Re: Inland Empire Energy Center Project—Docket No. 01-AFC-017
Visual Analysis and Revised Landscaping Plan—Response to PSA Workshop

***Visual Analysis
and
Revised Landscaping Plan***

Response to PSA Workshop

Inland Empire Energy Center

Figure B-1
Landscape Berm Schematic

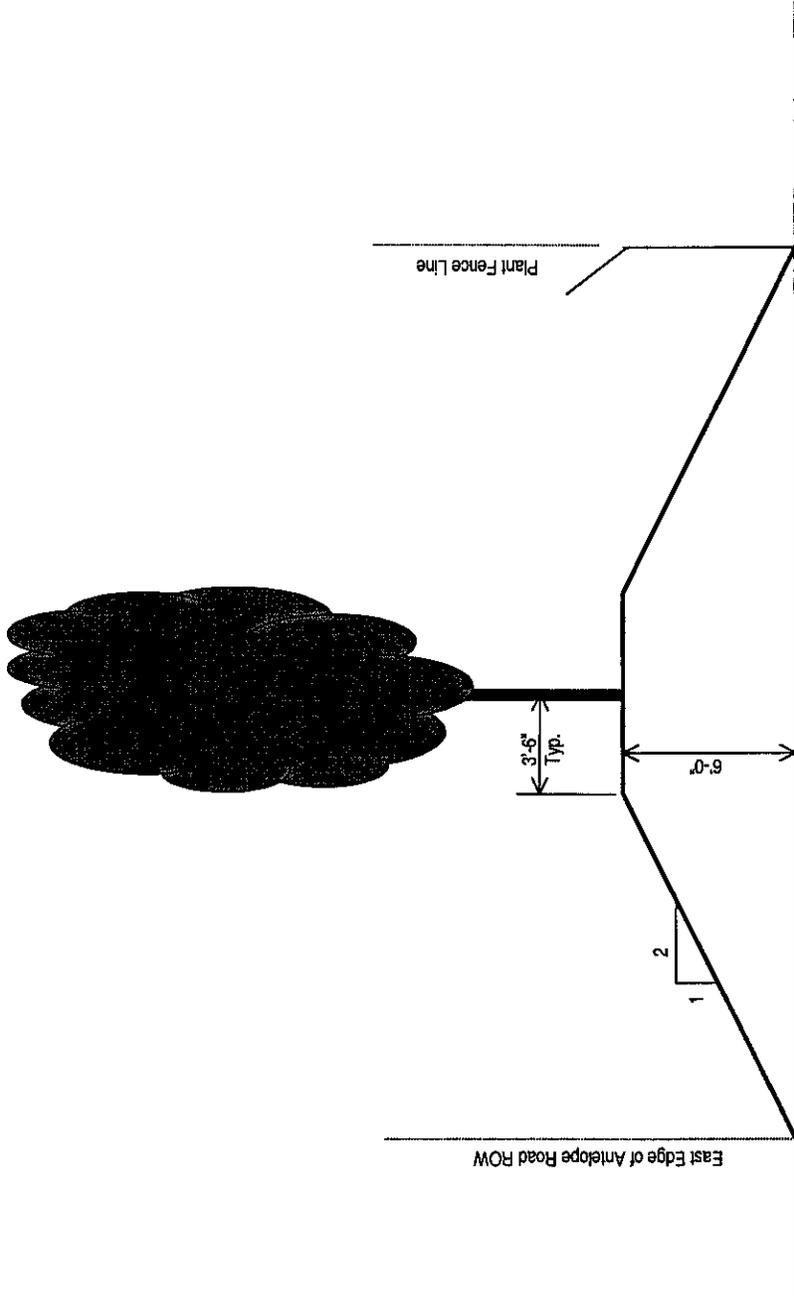
The Applicant is also proposing to add an approximately 6-foot high berm along the west side of the IEEC site, decreasing the time to screen the larger project structures from the key KOPs. The area to be bermed is shown in Figure 2, and Appendix B contains a schematic of the proposed berm. In addition, the Applicant is proposing to plant screening trees in the most-critical areas at mobilization rather than commercial operation in order to further reduce the time required to achieve the desired level of screening of the larger project elements.
